REQUEST FOR PROPOSALS (RFP)
AMENDMENT NO. Two
FOR TEMA New EOC and Administrative Building
Nashville, Davidson County, Tennessee

SBC PROJECT NO. 361/000-03-2025

DATE: September 1, 2026

THE RFP IS AMENDED AS FOLLOWS:

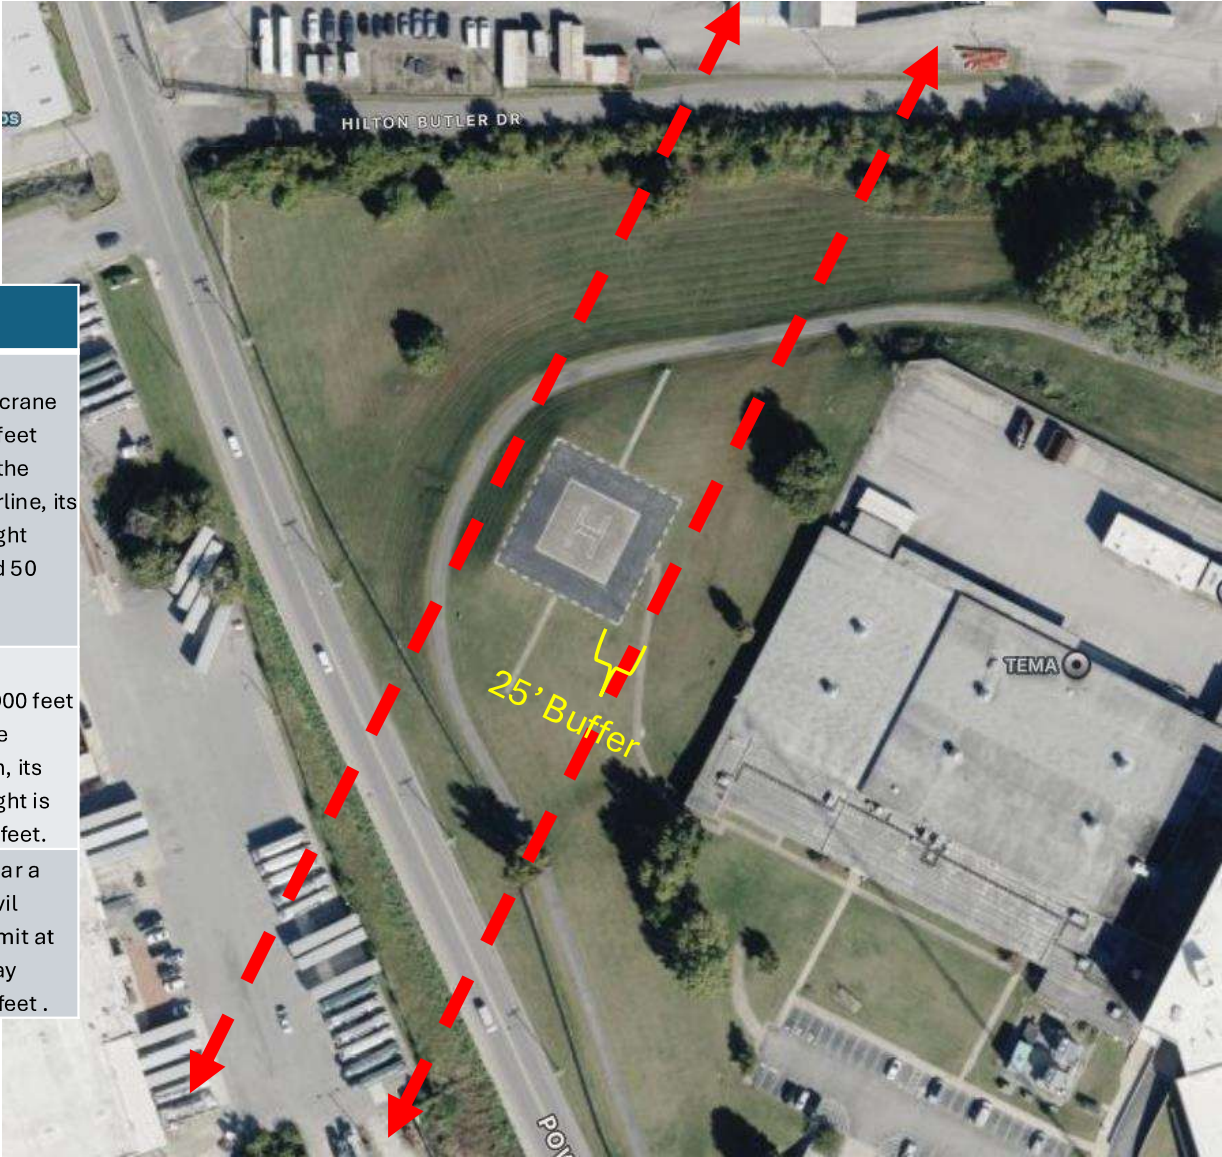
The Absolute Minimum Distance: The physical edge of the crane's maximum reach (the swing radius of the boom/jib) must remain entirely outside the **Primary Surface** of the helipad . Under **14 CFR § 77.23**, the Primary Surface coincides directly with the size and shape of the designated Take-Off and Landing Area (TLOF/FATO) . Further expanded on the next slide.

Safety Area Buffer: For operations under DOD guidelines, an additional **Safety Area** (extending at least 20 feet or 0.5 times the rotor diameter of the design helicopter beyond the FATO) must be kept entirely free of mobile obstacles like cranes. Further expanded on the next slide.

Approach/Departure Paths: If a crane is operating within the designated flight paths (which extend outward 4,000 feet for visual operations), it must not penetrate the sloped clearance plane .

Surface Type	Slope / Ratio	Horizontal Distance	Rule Detail
Transitional Surface (Sides)	2:1 (2 ft horizontal for every 1 ft vertical)	Up to 250 feet from centerline, after 250 feet, rule does not apply.	*Example-If a crane is parked 100 feet laterally from the helipad centerline, its maximum height cannot exceed 50 feet.
Military Approach Surface	10:1 (10 ft horizontal for every 1 ft vertical)	Up to 4,000 feet along flight path	If a crane is positioned 1,000 feet away along the approach path, its maximum height is limited to 100 feet.
Civil Approach Surface	8:1 (8 ft horizontal for every 1 ft vertical)	Up to 4,000 feet along flight path	If operating near a joint-use or civil helipad, the limit at 1,000 feet away would be 125 feet .

***Recommend using Civil Approach/Departure Surface rules due to local EMS aircraft in the area.**
